Memorandum for Record

August 12, 2021

Subject: Suitability Determination Memorandum and Antidegradation Assessment for the Port of Everett North Marina Maintenance Dredging, in Everett, Washington (NWS-2021-528) for placement at the Port Gardner non-dispersive disposal site.

Figure 2. Port of Everett North Marina DMMUs with proposed and actual sample locations

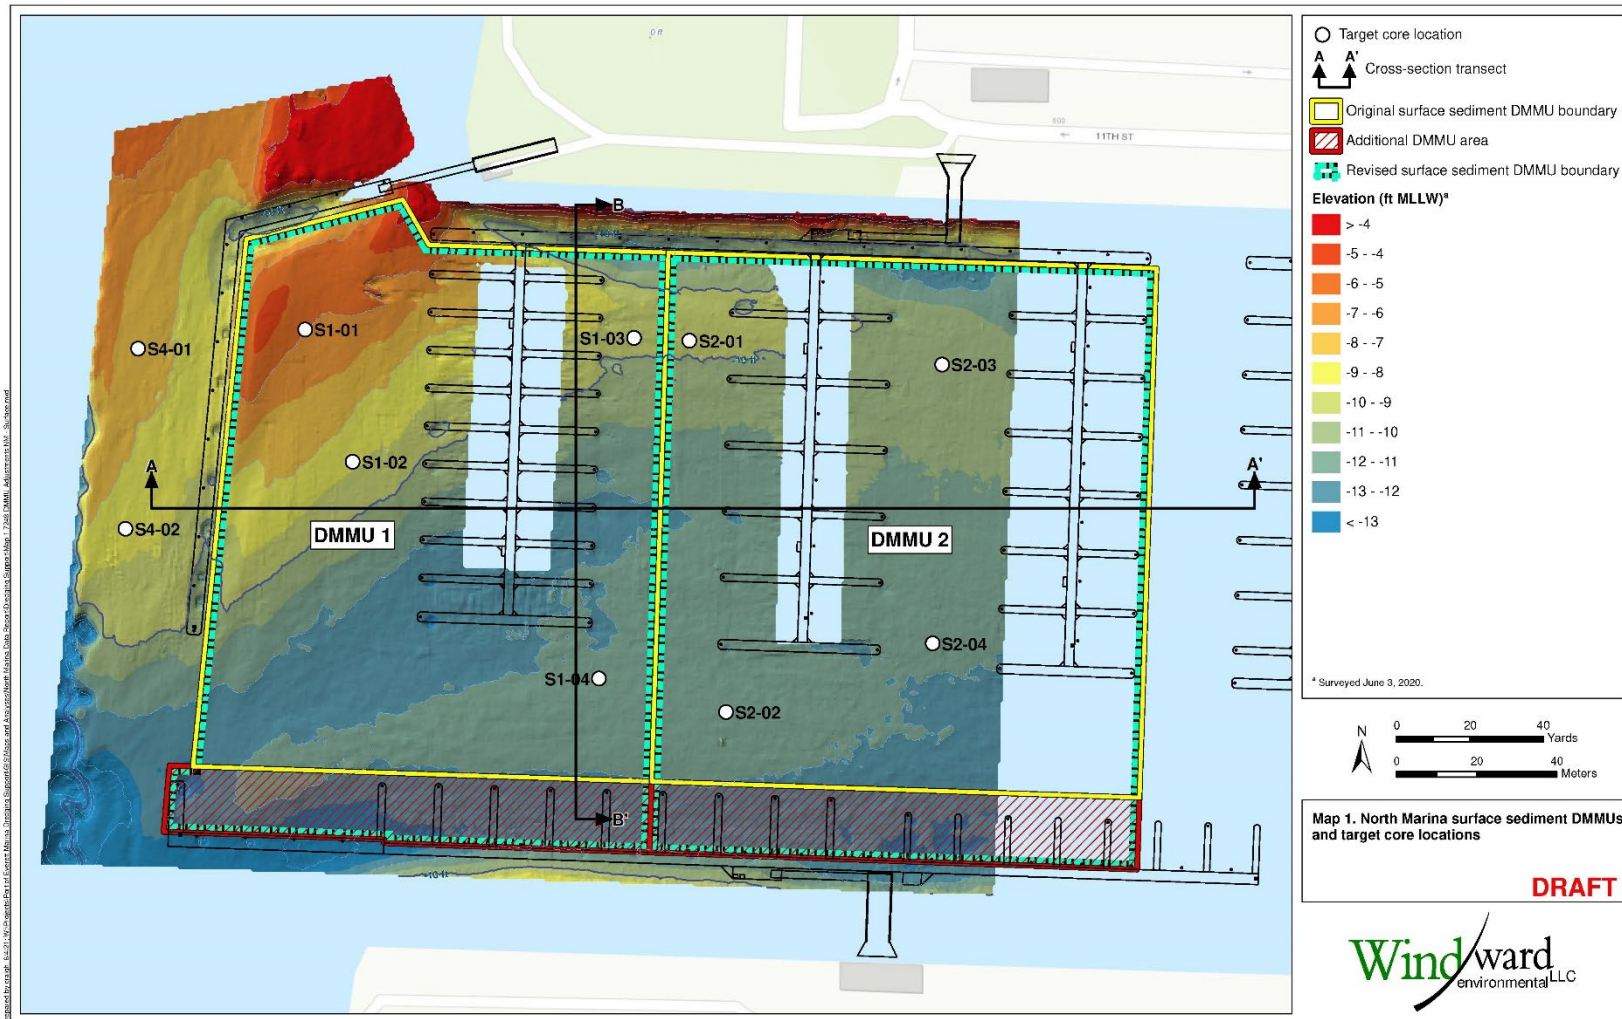
Ten cores were collected as shown in Figure 2 and detailed in Tables 1 and 2. Most of the accepted cores met all acceptability criteria; one core (at location S4-01) was accepted with less than 75% recovery and was not able to core into the proposed Z-layer. After several attempts, which were complicated by woody debris in the dredge prism, the core with the highest recovery and deepest penetration was deemed acceptable. All accepted cores were composited per the approved SAP (Table 1) and analyzed for the DMMP chemicals of concern plus tributyltin and Dioxins/Furans. All analyses were conducted by Analytical Resources Incorporated in Tukwila, Washington.
